Our Ref: SK/11248/jj

5 June, 2019

RE: REVIEW OF REVISED CAR PARKING ARRANGEMENTS
FOR EASTLAKES SHOPPING CENTRE
NORTHERN SITE DEVELOPMENT

COMPLIANCE CHECK
AS2890.1-2004 &
AS2890.2-2002

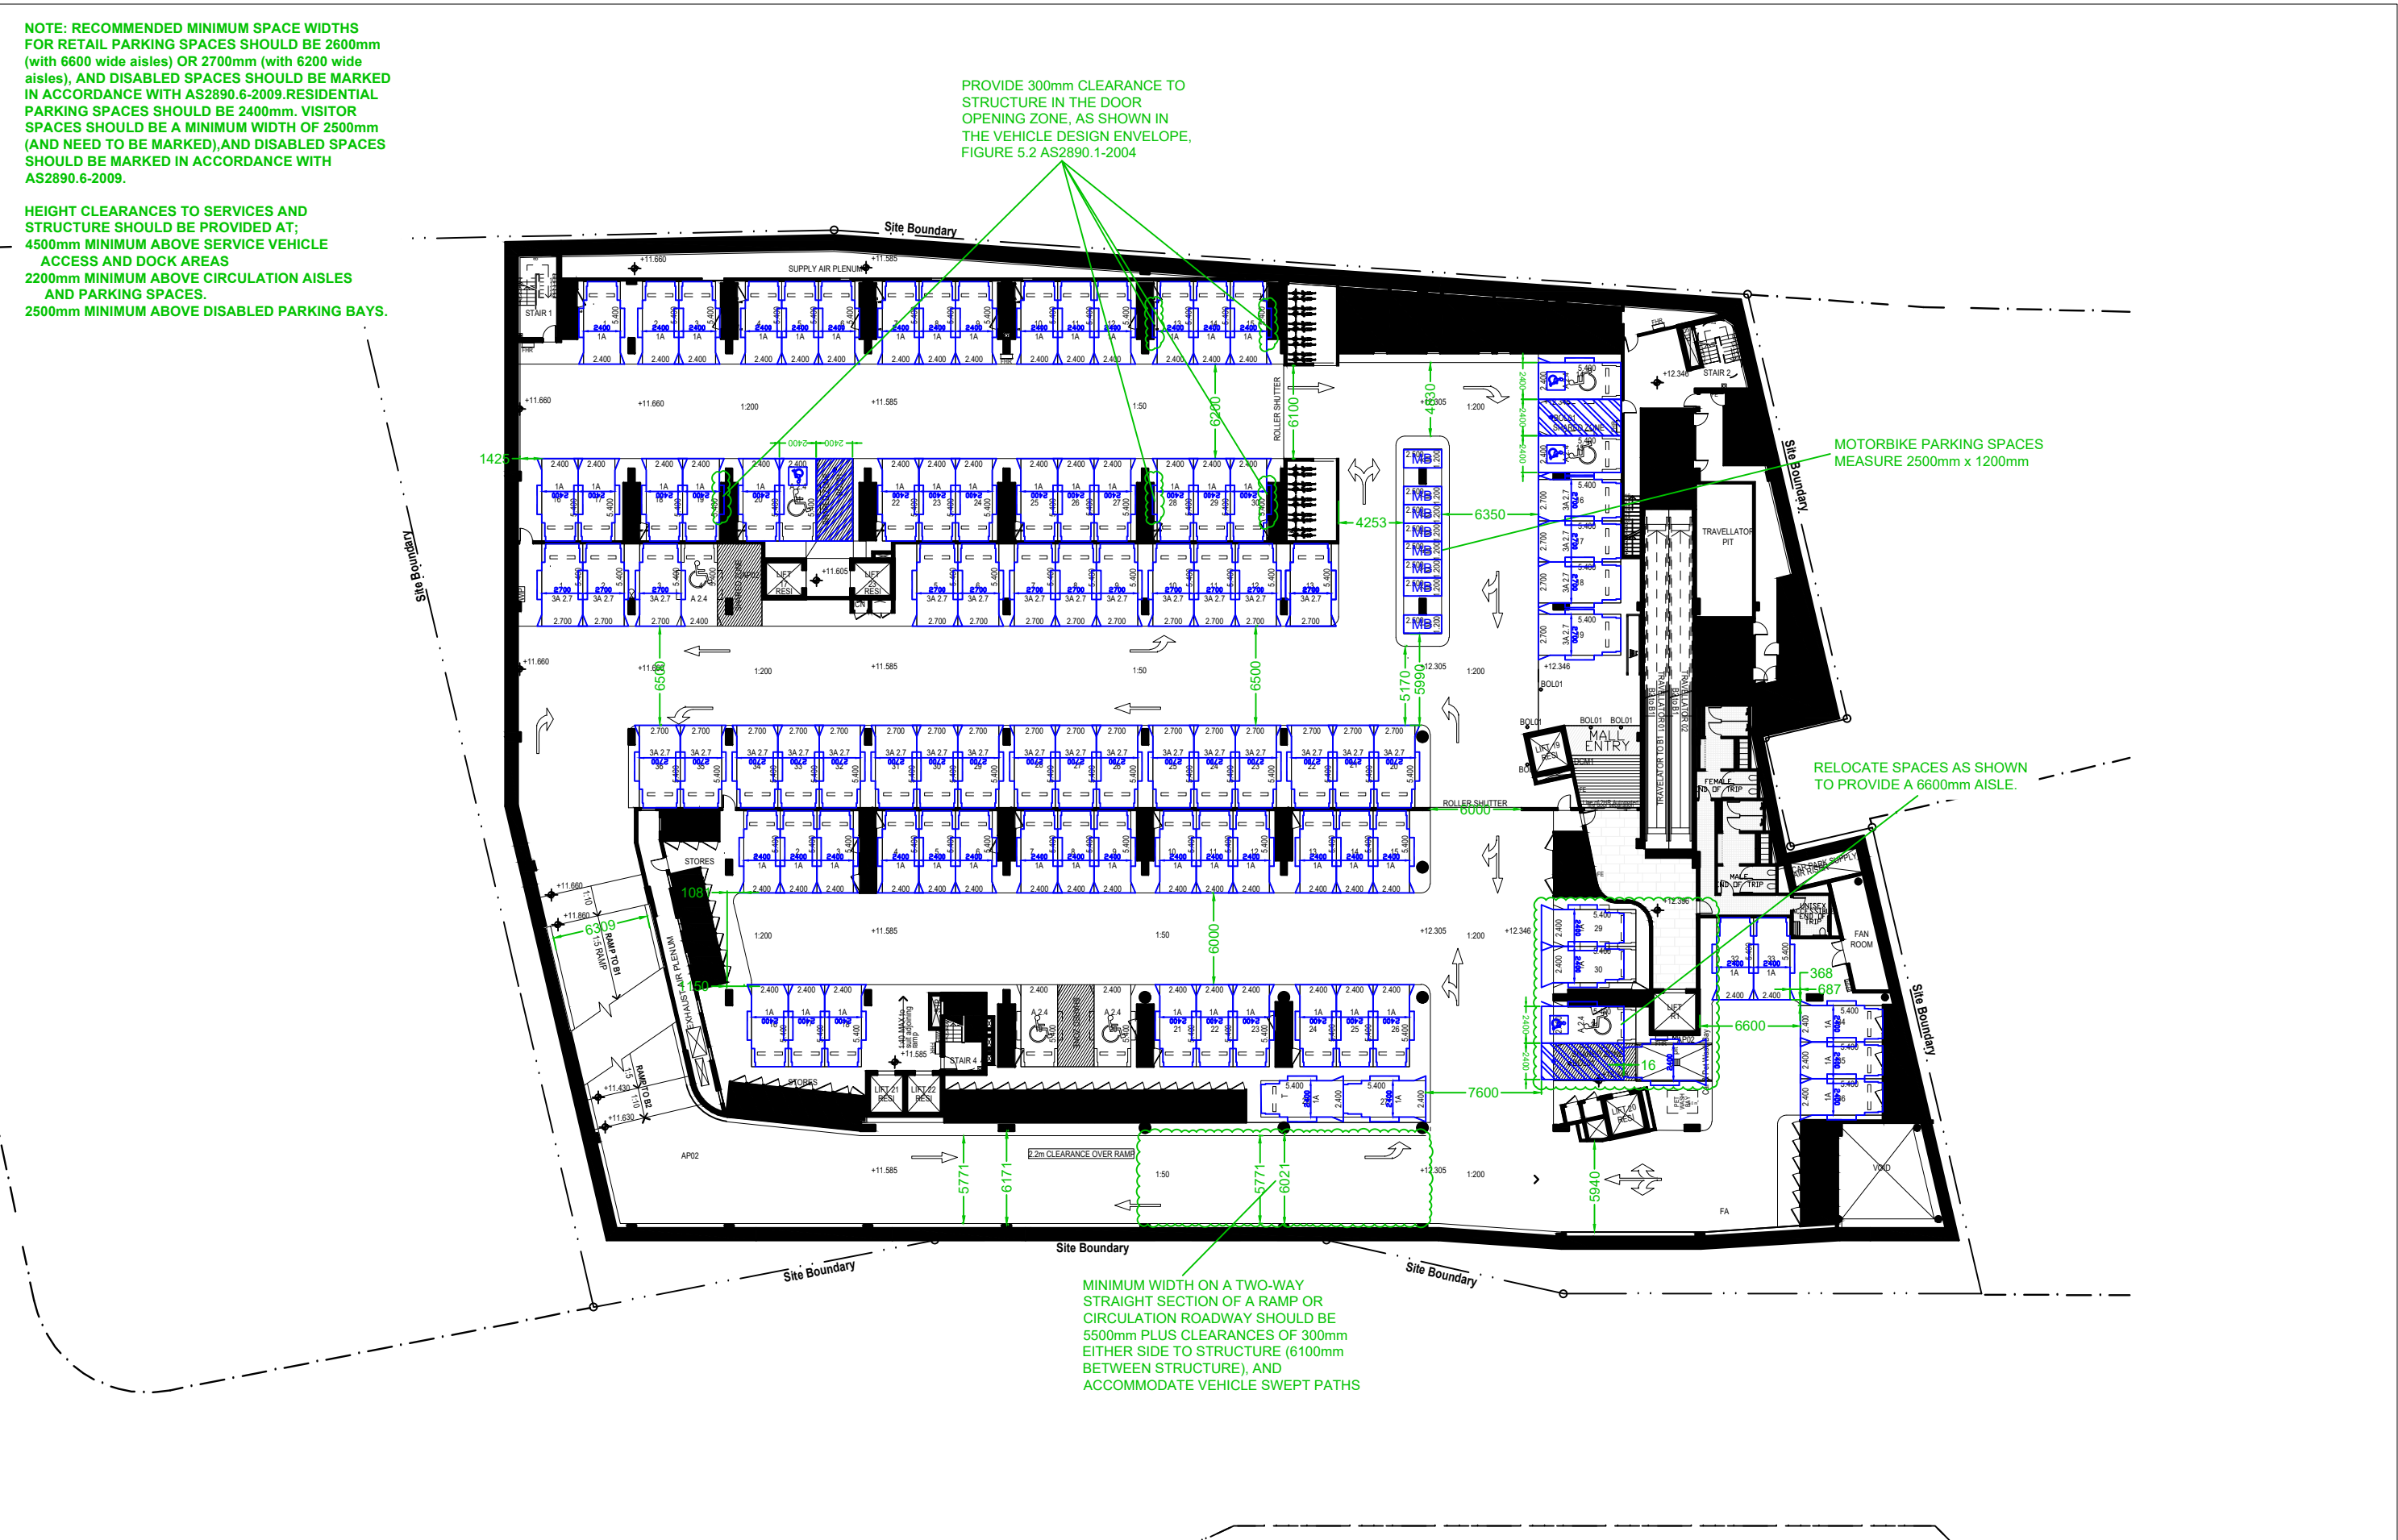
NOTE: RECOMMENDED MINIMUM SPACE WIDTHS FOR RETAIL PARKING SPACES SHOULD BE 2600mm (with 6600 wide aisles) OR 2700mm (with 6200 wide aisles), AND DISABLED SPACES SHOULD BE MARKED IN ACCORDANCE WITH AS2890.6-2009. RESIDENTIAL PARKING SPACES SHOULD BE 2400mm. VISITOR SPACES SHOULD BE A MINIMUM WIDTH OF 2500mm (AND NEED TO BE MARKED), AND DISABLED SPACES SHOULD BE MARKED IN ACCORDANCE WITH AS2890.6-2009.

HEIGHT CLEARANCES TO SERVICES AND STRUCTURE SHOULD BE PROVIDED AT;
4500mm MINIMUM ABOVE SERVICE VEHICLE ACCESS AND DOCK AREAS
2200mm MINIMUM ABOVE CIRCULATION AISLES AND PARKING SPACES.
2500mm MINIMUM ABOVE DISABLED PARKING BAYS.

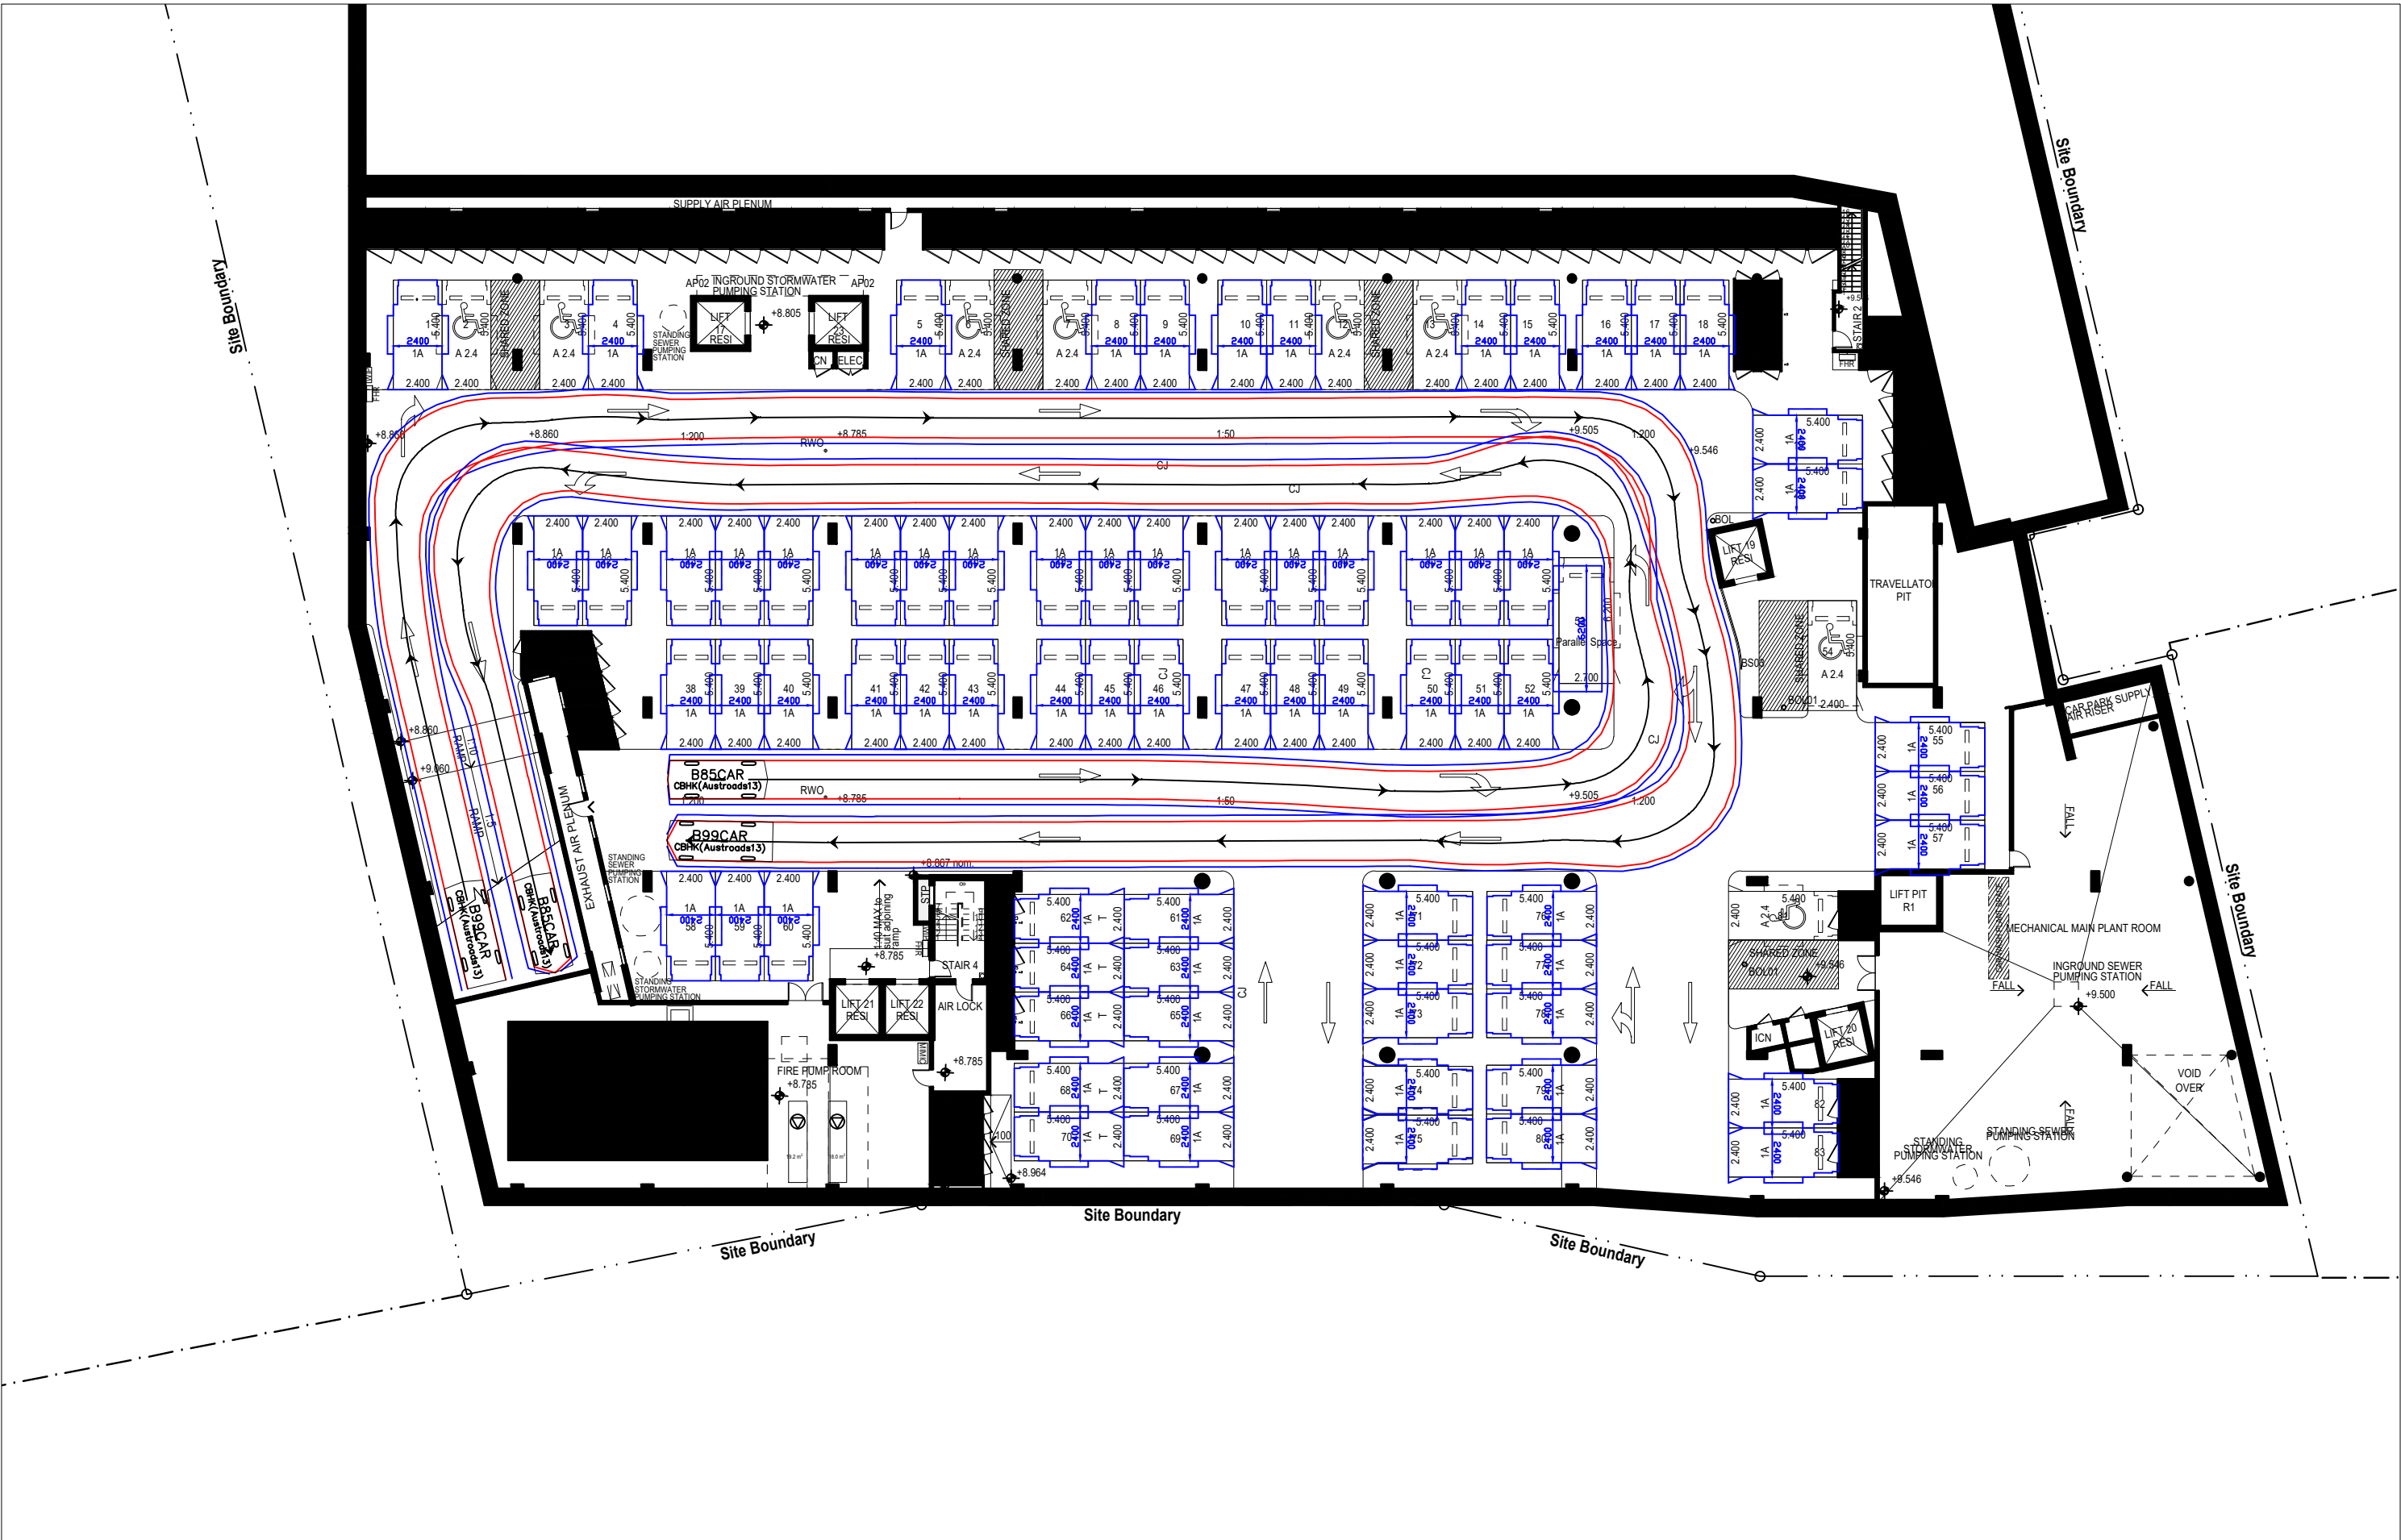
9. A small area of residential parking, including a proposed car wash bay, is located within the south eastern corner of basement level 2. This area should be reconfigured as shown on Figure 3 of the attached compliance review, in order to provide appropriate access to the adjacent residential parking spaces.
